# CITY OF ALBUQUERQUE

*Planning Department*

**Re: Stormwater Entering Juan Tabo Hills Subdivision Unit 2 and Unit 1 at the West End of Raton Avenue, City Project Number 756183**

## Location of Inlet

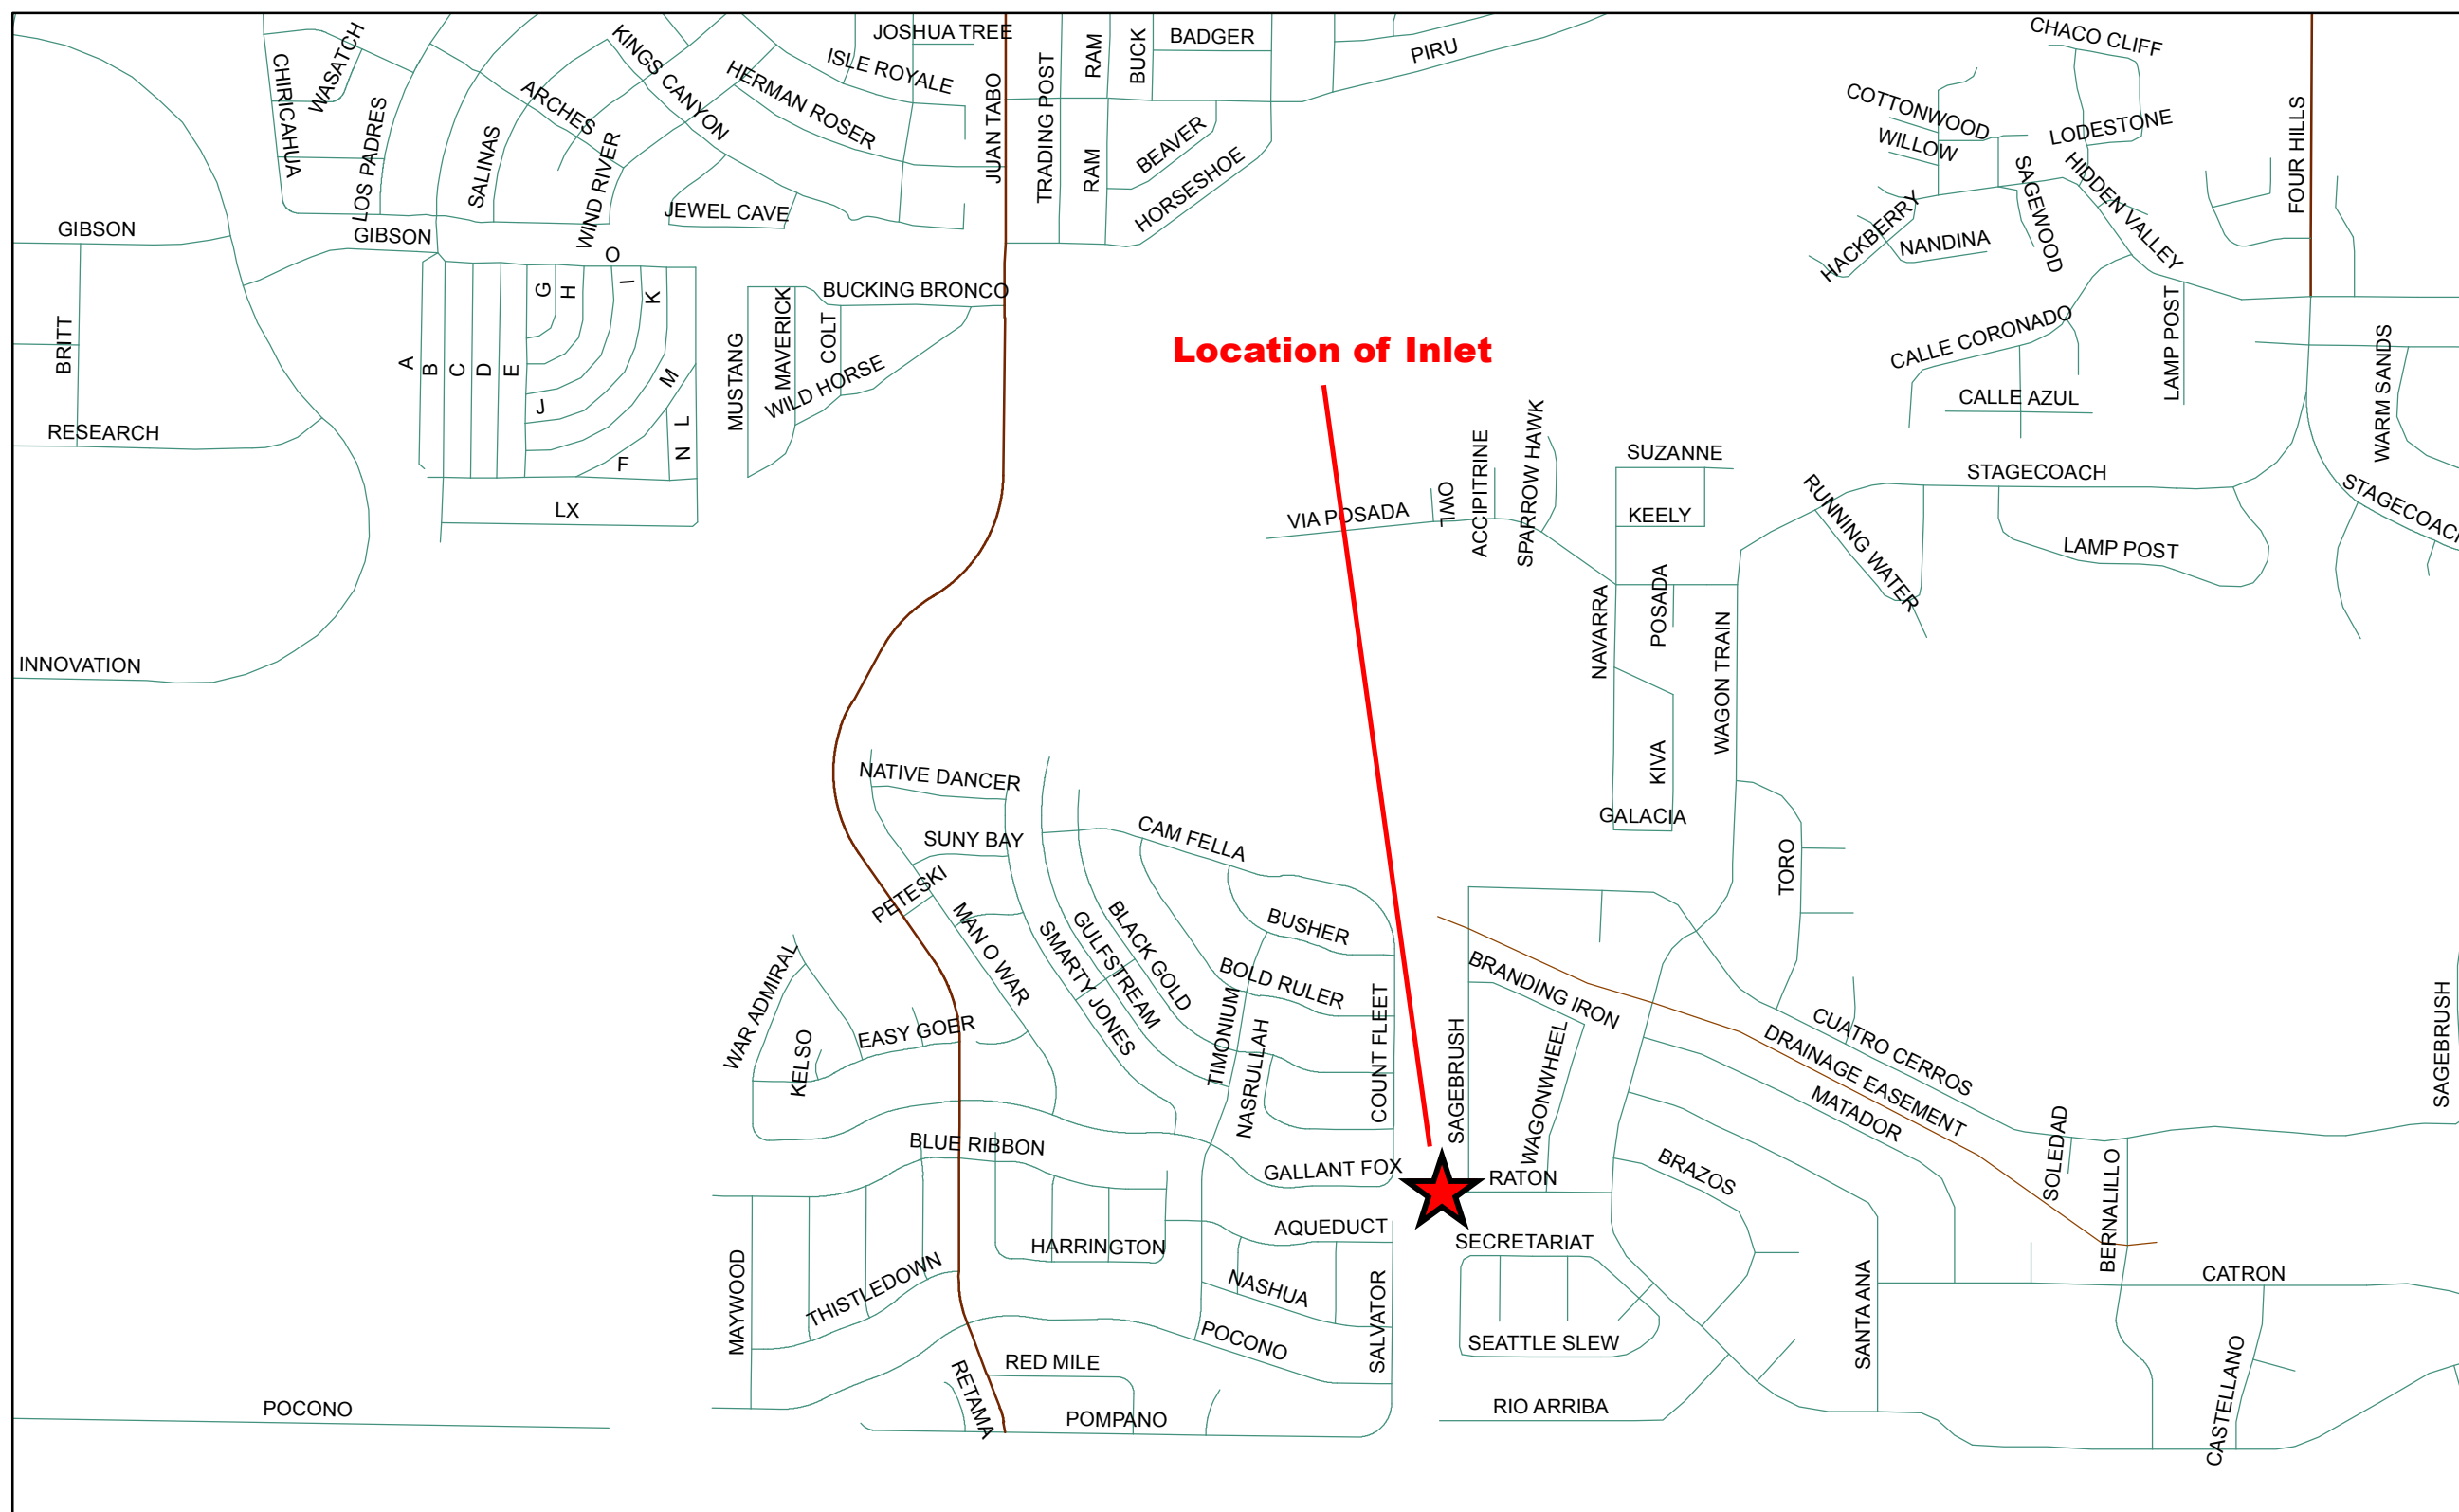
Hydrology has received drainage complaints, July of 2011 and September of 2013, concerning stormwater bypassing the storm drainage cattle guard inlet built at the west end of Raton Ave, Exhibit 1. The inlet was built with City Project Number 756183, Juan Tabo Hills Subdivision, Unit 1. I have included the pertinent record drawing sheets for reference, Exhibit 2. The cattle guard inlet was designed to protect Juan Tabo Hills Unit 1 and Unit 2 from the offsite flows from Four Hills. The stormwater is eroding the emergency access road and the Homeowner Association (HOA) open space area, Exhibit 3. This is due to the stormwater bypassing the inlet. The HOA is paying to maintain the erosion concern.

It appears a portion of the drainage from Raton Avenue bypasses the cattle guard inlet. Per the approved drainage report, 198 cfs is flowing in Raton Avenue. It also appears that the inlet was designed without a clogging factor. The Development Process Manual recommends a 15% clogging factor for Type "C" inlets when there is not a Type "A" inlet upstream, which there is not.

Per a site visit September 26, 2013 the inlet was mostly clean, with some debris on the cattle guard inlet grate near the north side of the street. It appears that the stormwater is at too high of a velocity to be captured by one inlet. Mr. Krenik also indicated in his e-mail dated August 5, 2011, the street is not level and the stormwater stays to the north side. A similar cattle guard inlet was built at the end of Arriba Avenue. It seems to be functioning properly. Per the approved drainage report, 30 cfs is flowing in Arriba Avenue.

The City requests that Mark Goodwin and Associates correct the drainage problem at the end of Raton Avenue. Please contact our City Hydrologist, Curtis Cherne, to schedule a meeting to discuss.

CATTLE GUARD INLET (NORTH SIDE)  
 N.T.S. PER COA DWG 2271, 2272 & 2220

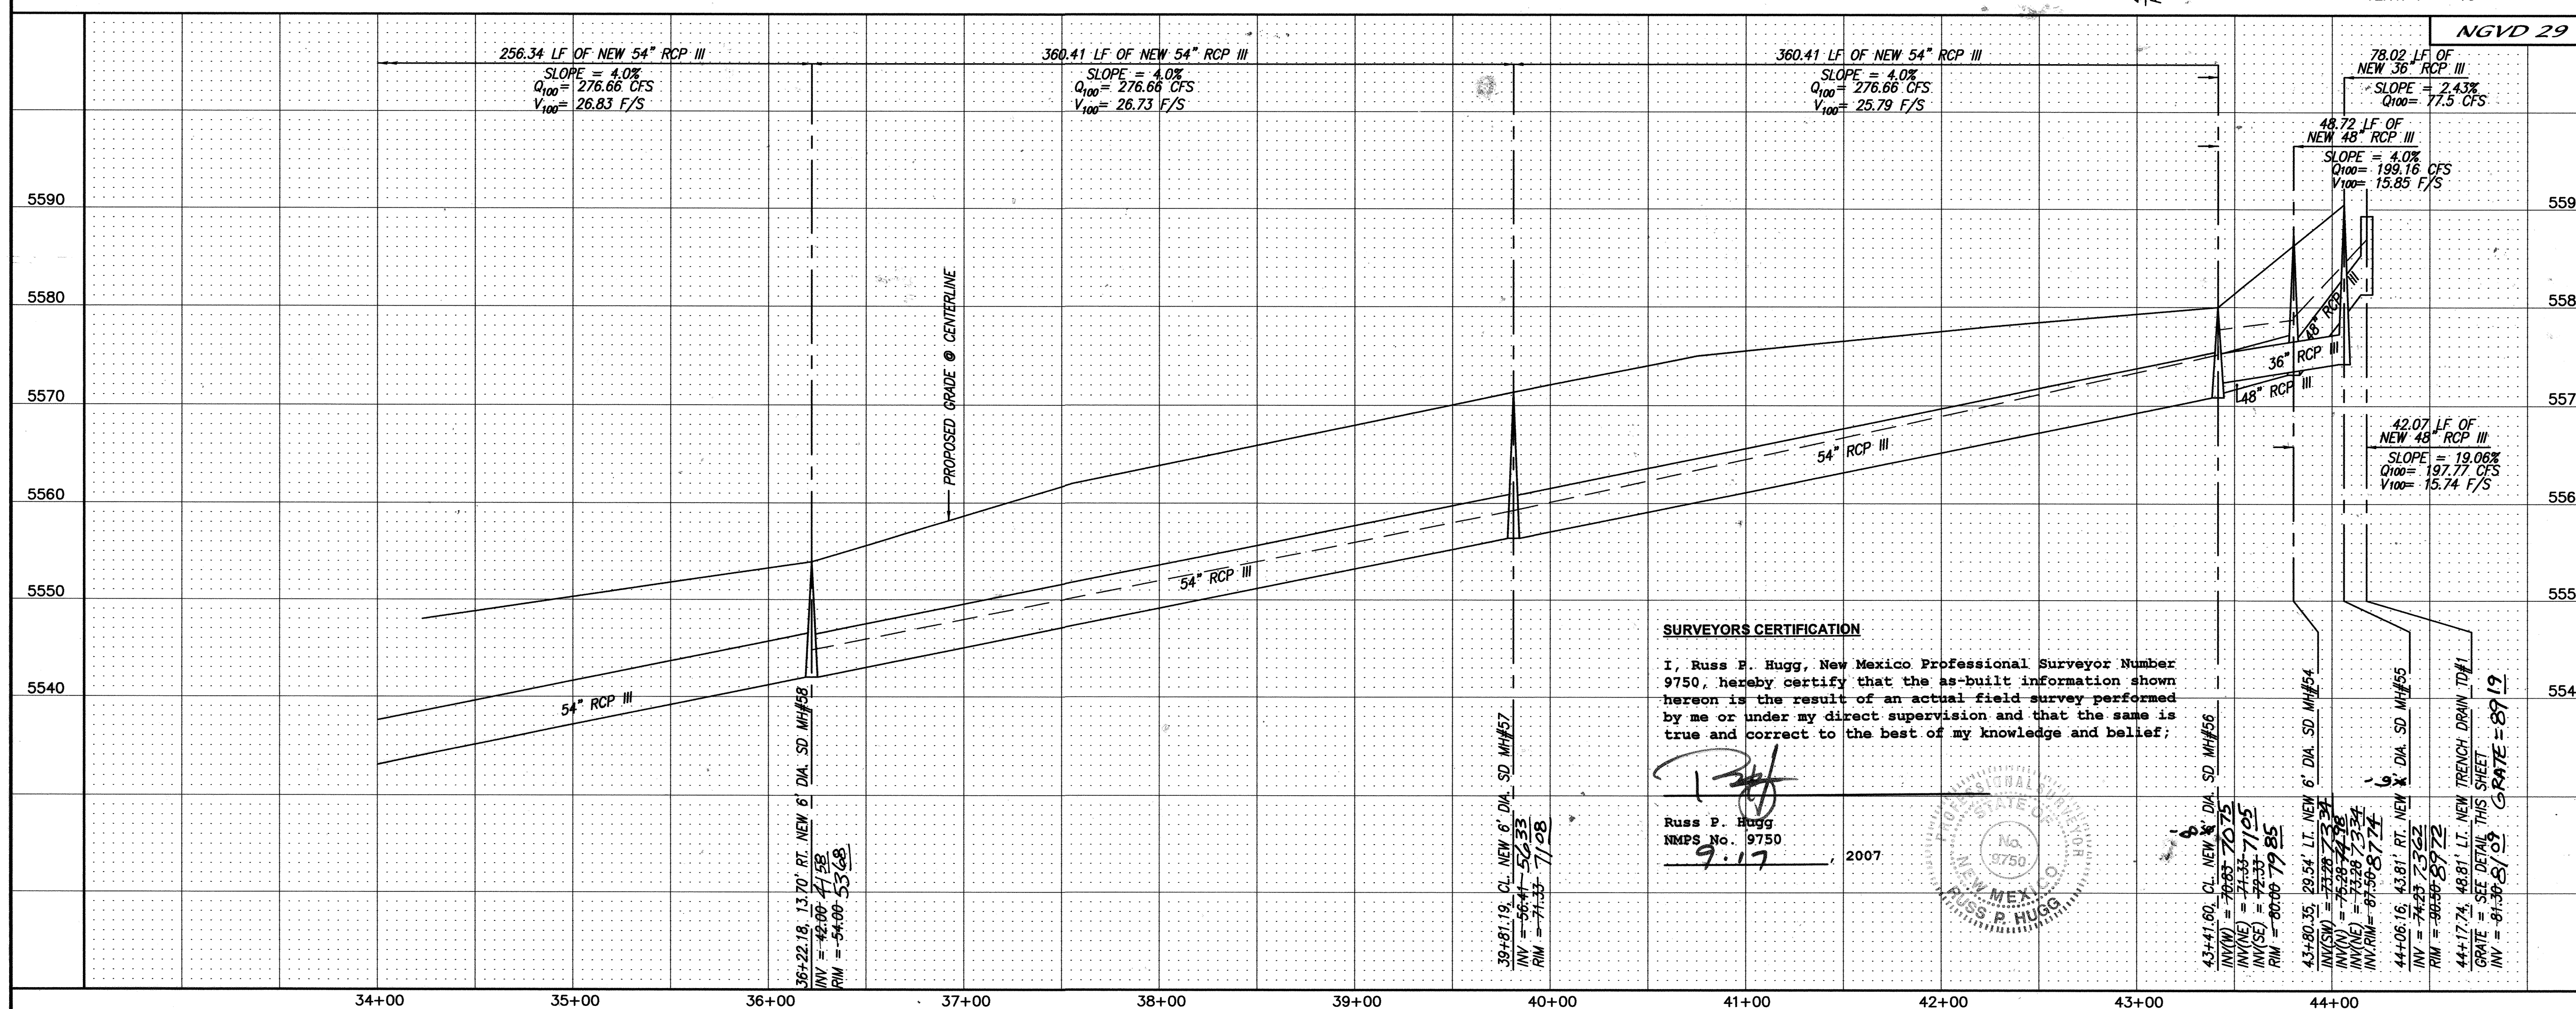
There seems to be some discontinuity between the calcs for the street with the crown and then without the crown, d, A, V and then the Q that the grate will accept. Also, where does the efficiency number come into play?

If you apply a 50% clog to the grate part of the inlet, this leaves a substantial gap.

I am not sure two A inlets will be enough. May need the inlets and the header curb.

After our lengthy discussion. We agreed that you would submit some calculations to support a fix. We talked about building a sump condition for the cattle guard, installing an inlet(s), and picking up flows in the inlet west of the fence.
